**RE: Wintergreen Apartments  
10800 Golf Course Rd NW  
Grading & Drainage Plan and Drainage Report  
Engineer's Stamp Date: 08/26/21  
Hydrology File: A12D008D**

**RE: WINTERGREEN APARTMENTS  
10800 GOLF COURSE RD NW  
GRADING & DRAINAGE PLAN AND DRAINAGE REPORT  
HYDROLOGY FILE: A12D008D**

**RE: WINTERGREEN LUXURY APARTMENTS  
10820 GOLF COURSE RD NW  
AMAFCA COMMENTS**

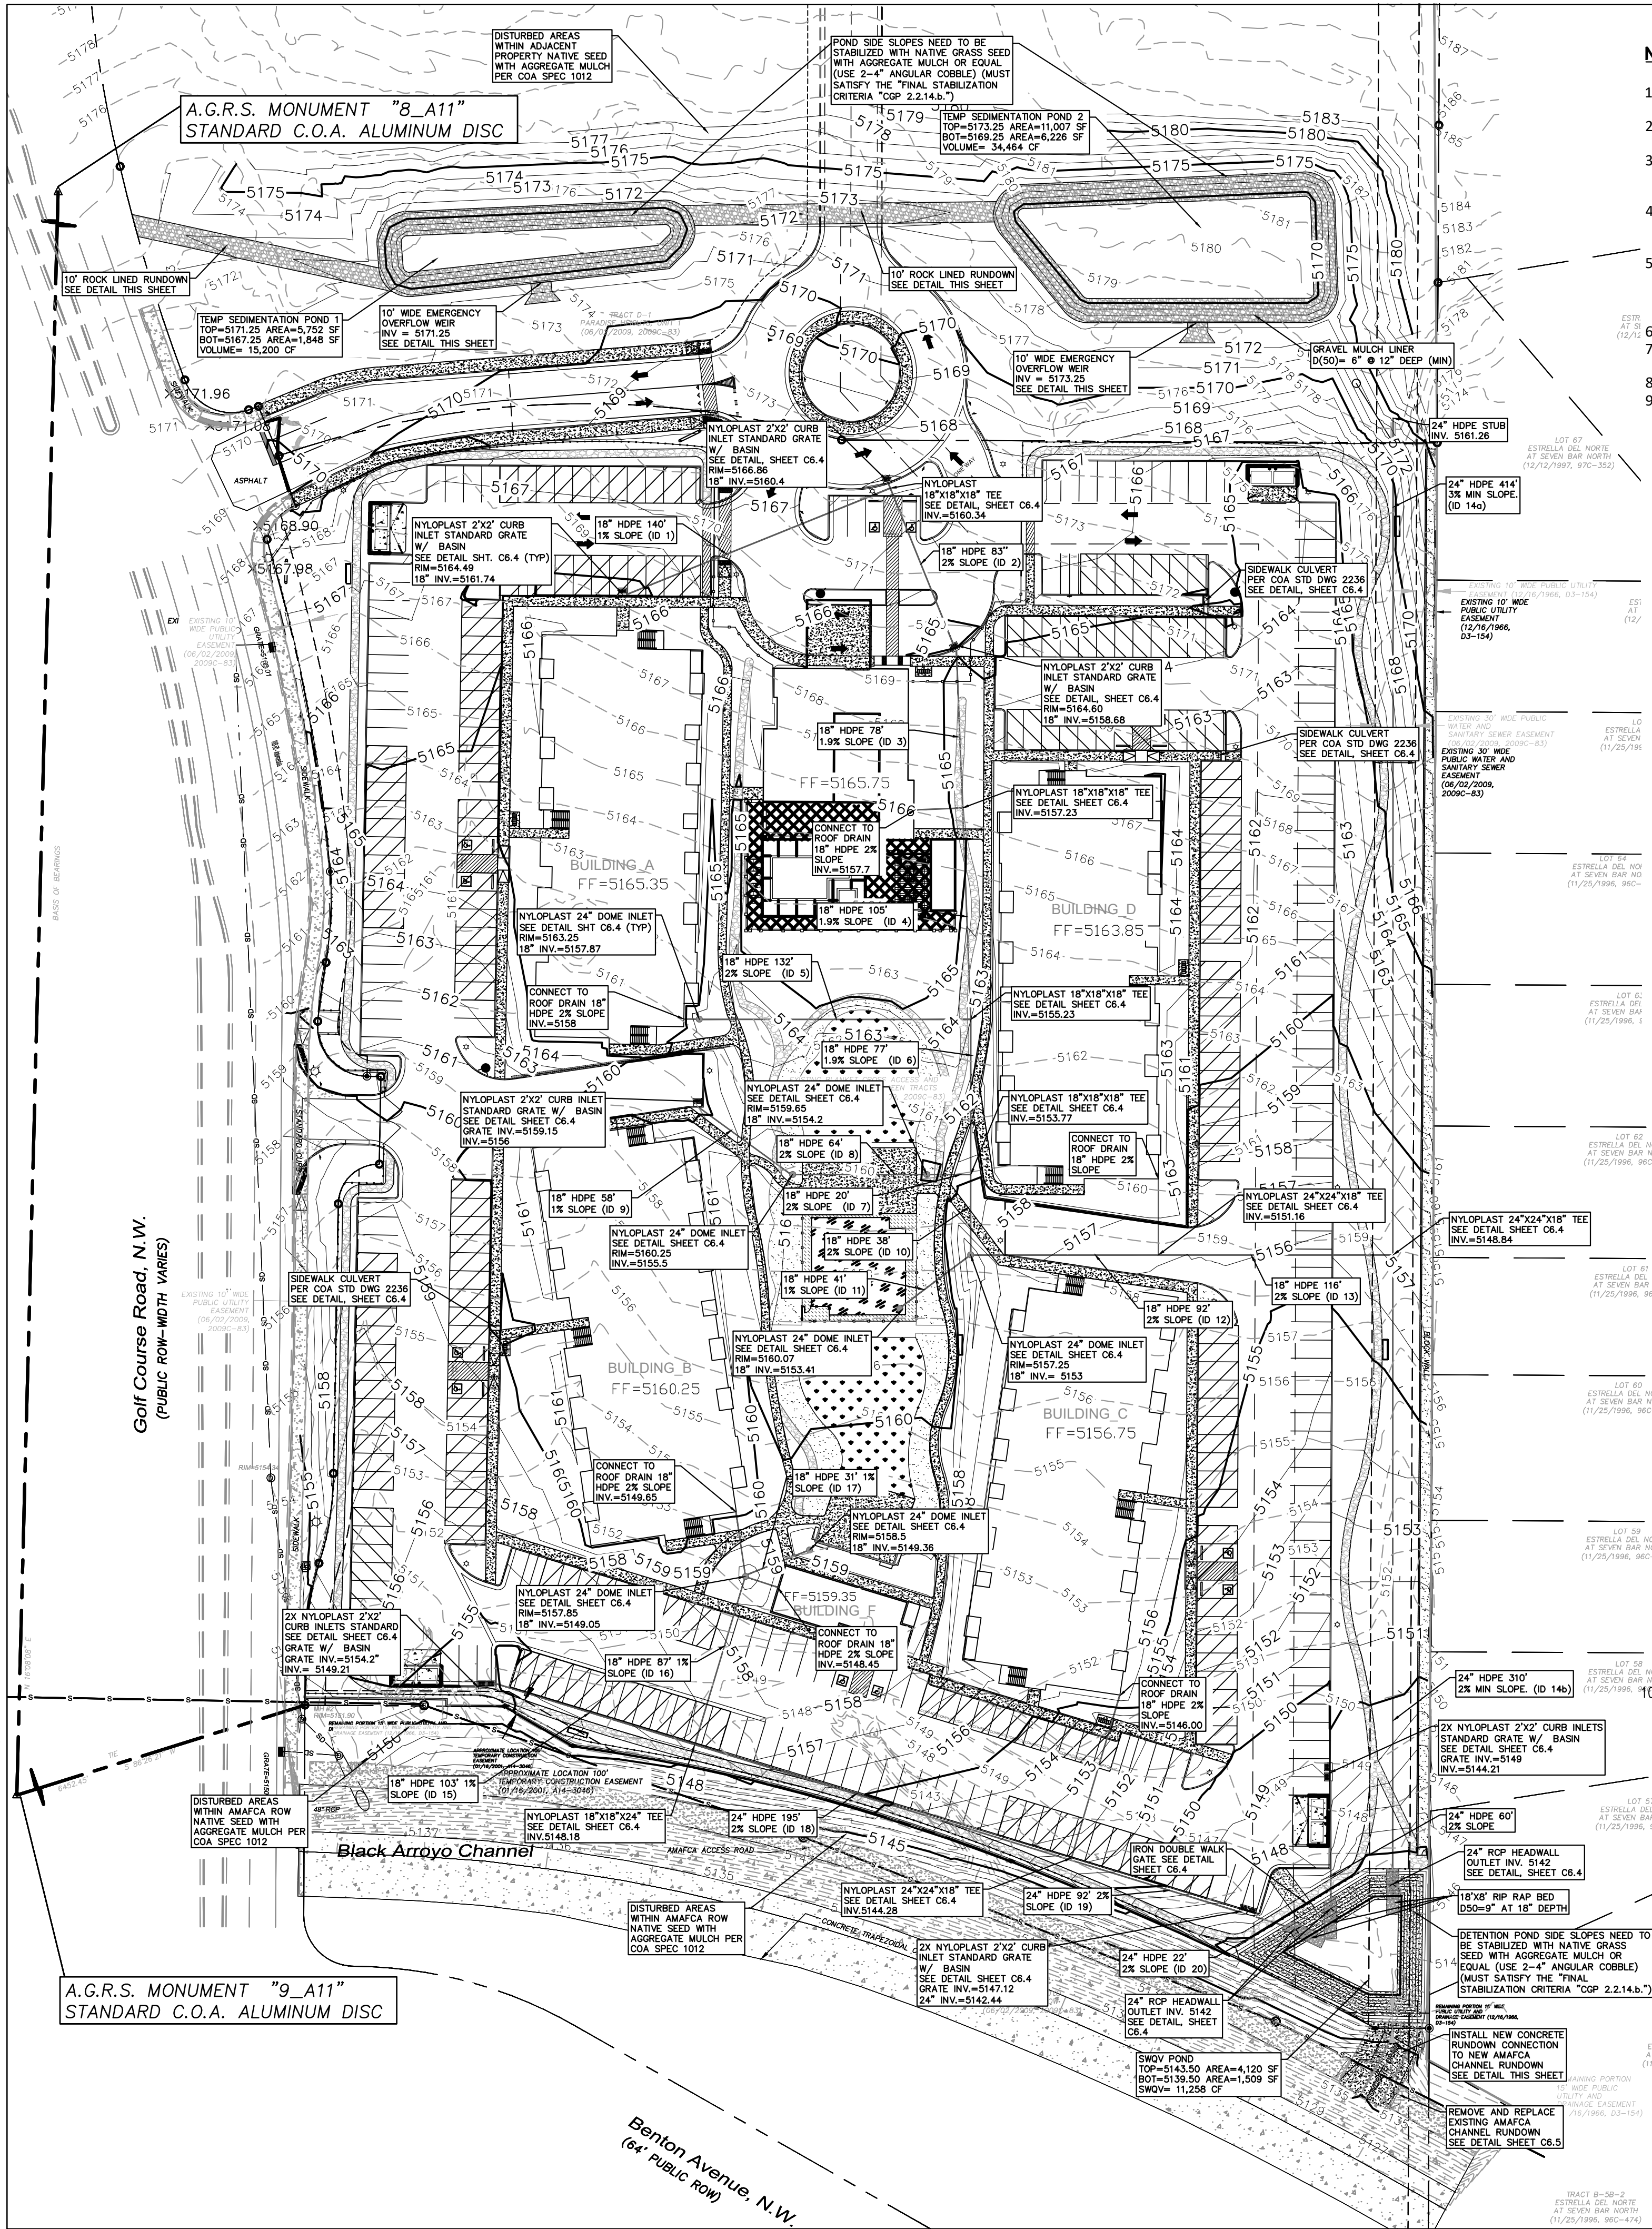
**Sheet C3.1 Grading and Drainage Basin Map:**

1. You are restricting future developed flows from Basin D1 (and what is equivalent to Tract D-1) from 28.92 cfs to 19.5 cfs, correct?

**Response: Correct**

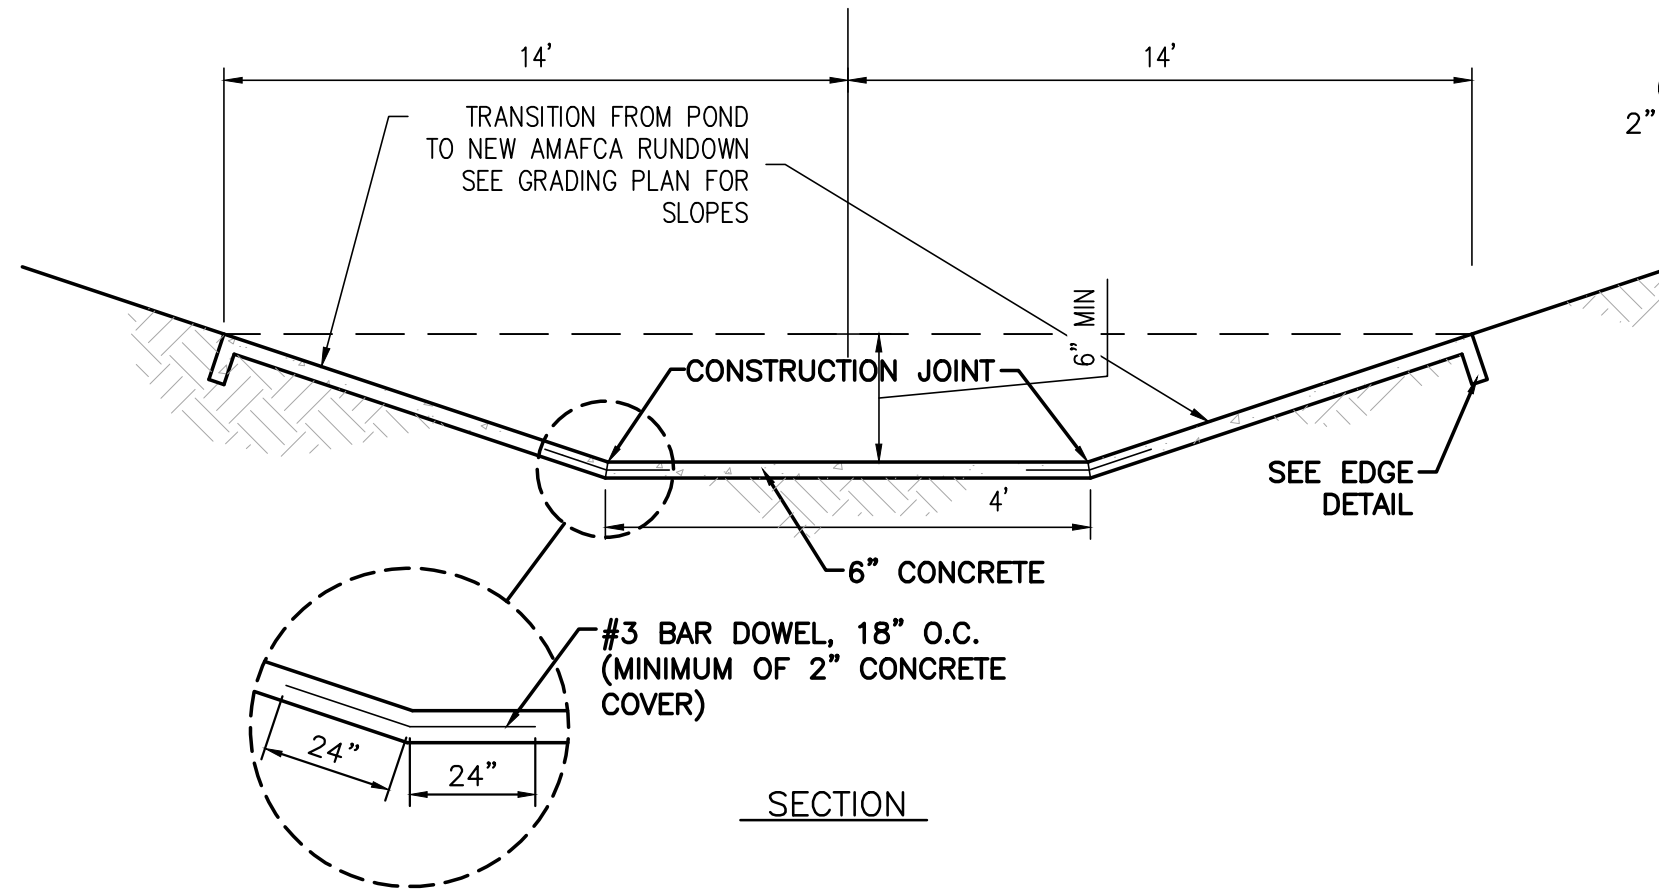
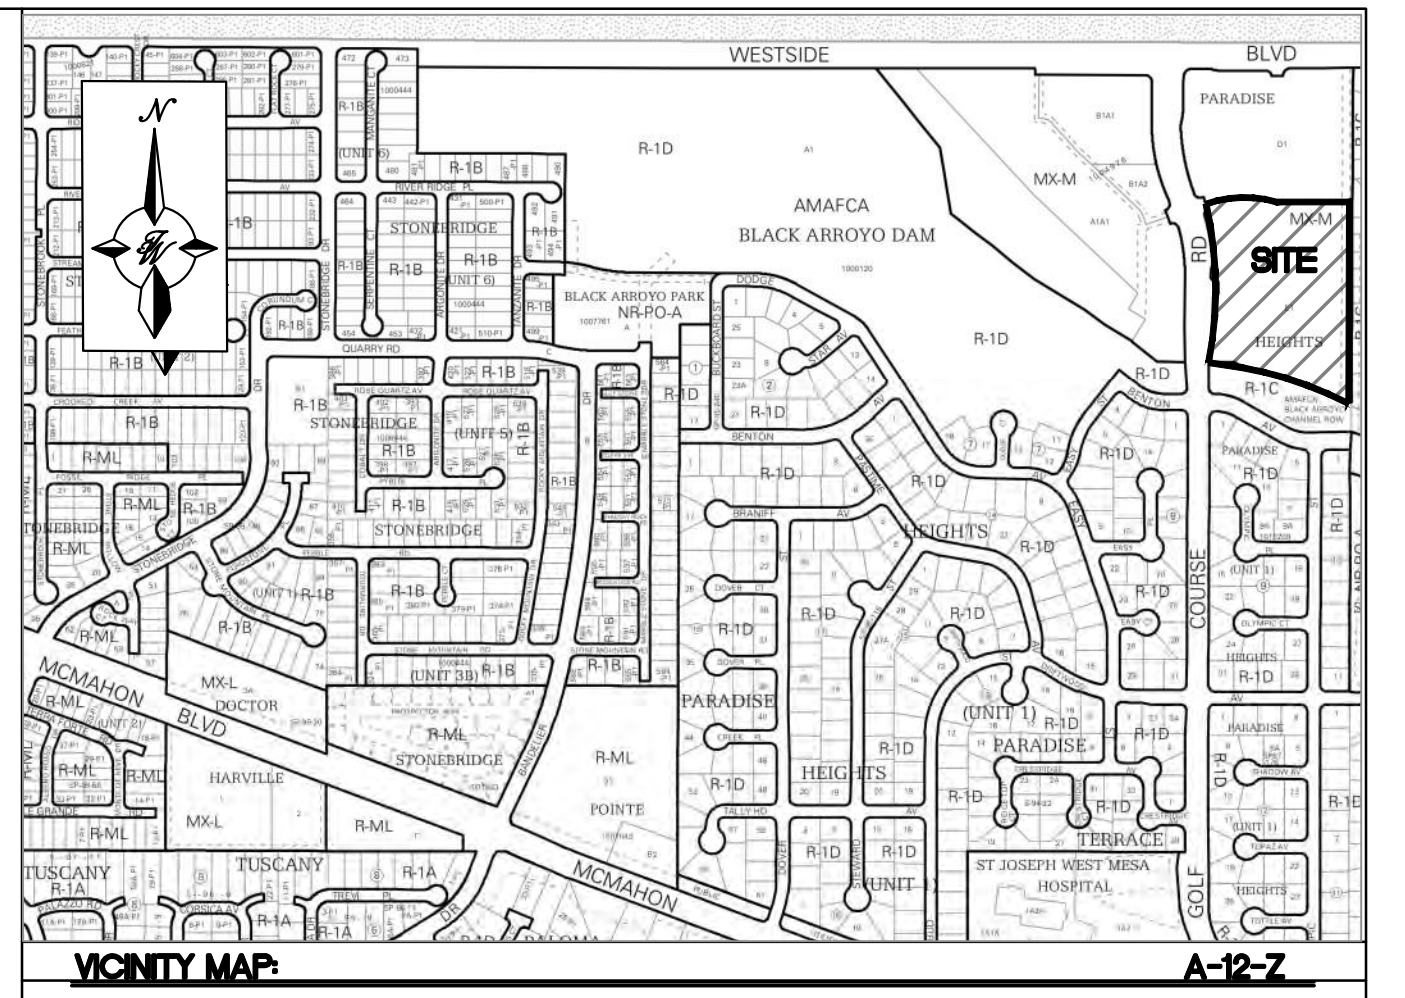
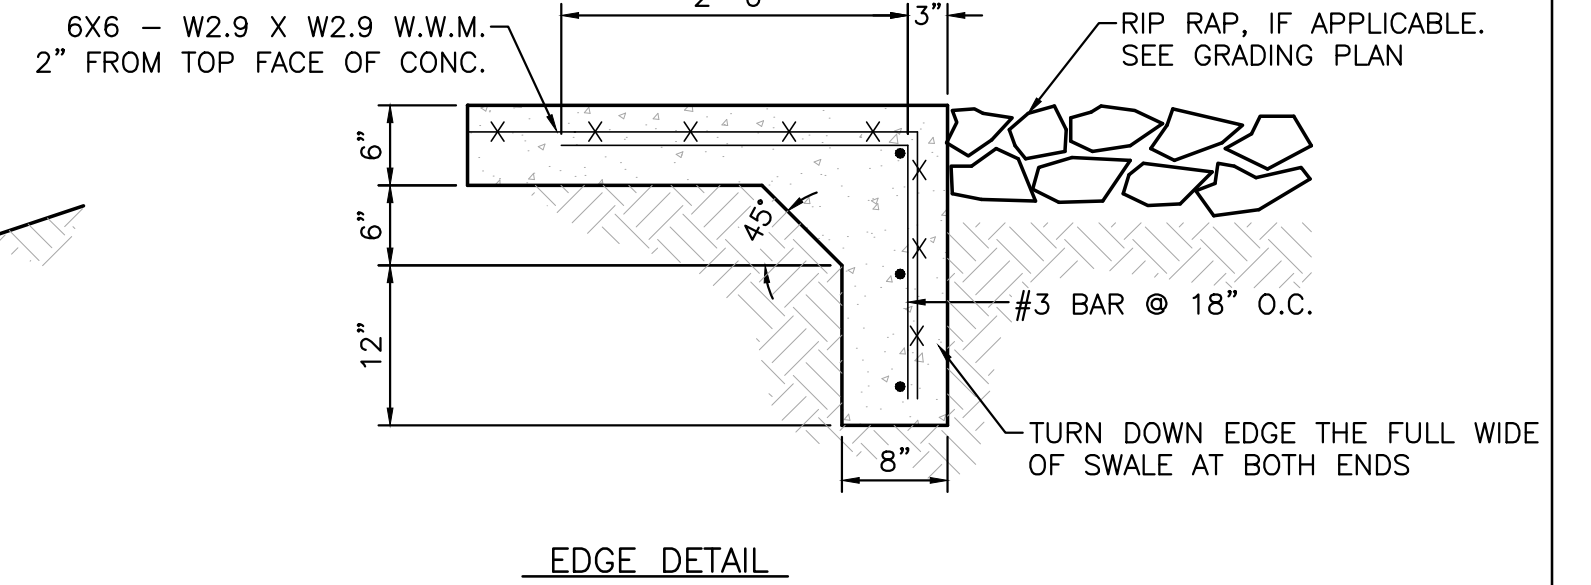
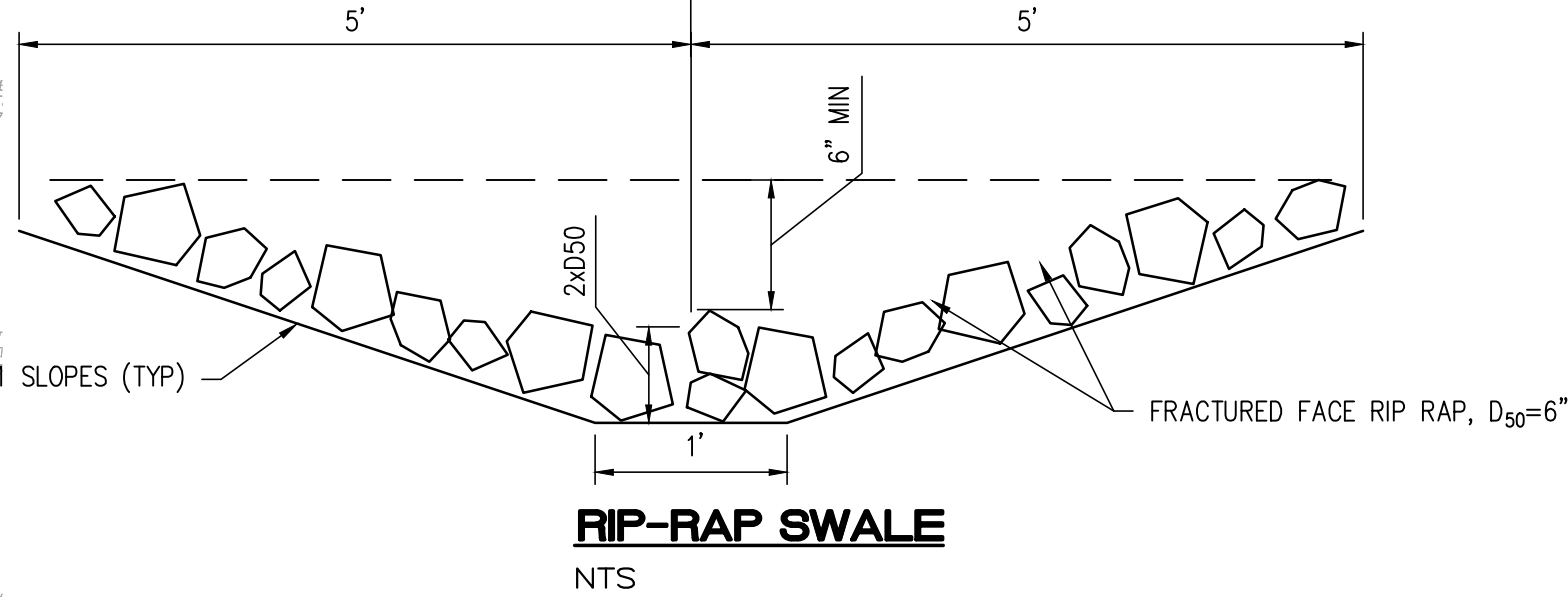
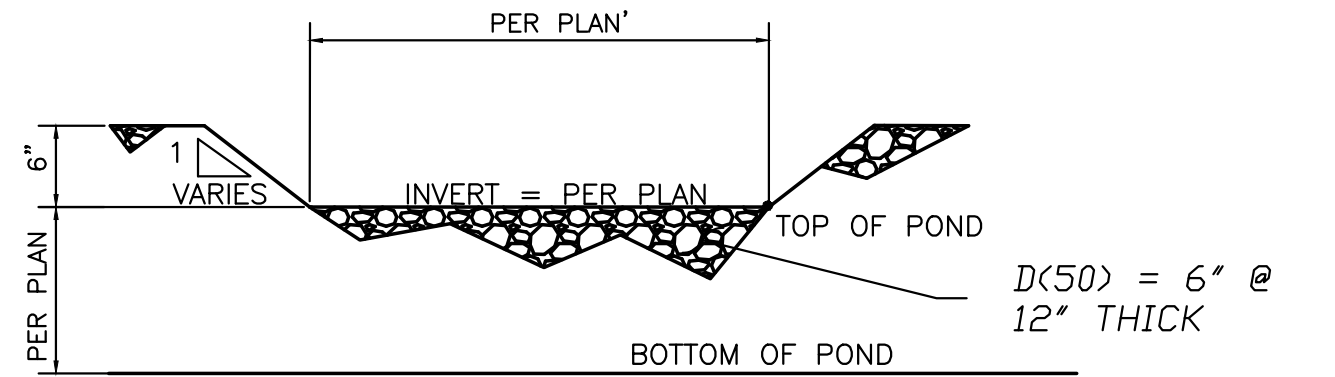
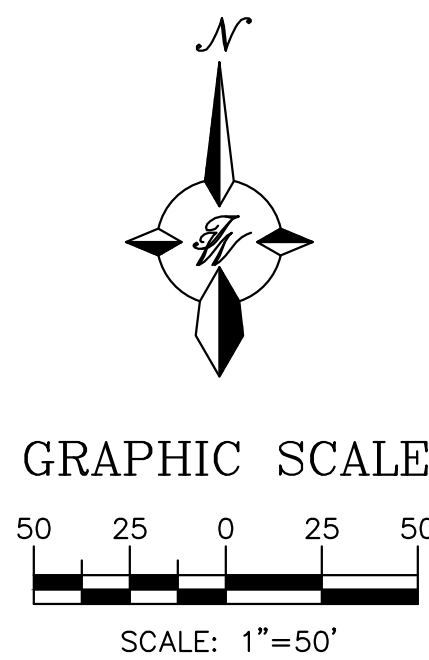
6. Please reference City of Albuquerque standard detail No. 2236 – Sidewalk Culvert with Steel Plate Top at the sidewalk culvert.

**Sheet C3.2 Grading and Drainage Plan:**

1. The water quality pond has pretty steep slopes. How is it going to be access and maintained? You have enough room behind the parking to add an access ramp.

2. If the pipe that is being run down the east side of the property is to account for the future developed flows from Tract D1, why is that flow not reflected in the pip capacity calculations?

**Response: See updated sheet C3.2 and detail No. 2236 was added to sheet C6.4.**

**Response: See sheet C3.2, access ramp with gate added to water quality pond.**

**Response: Pipe capacity calculation updated to reflect future development flow, see Grading and Drainage Report Appendix A.**
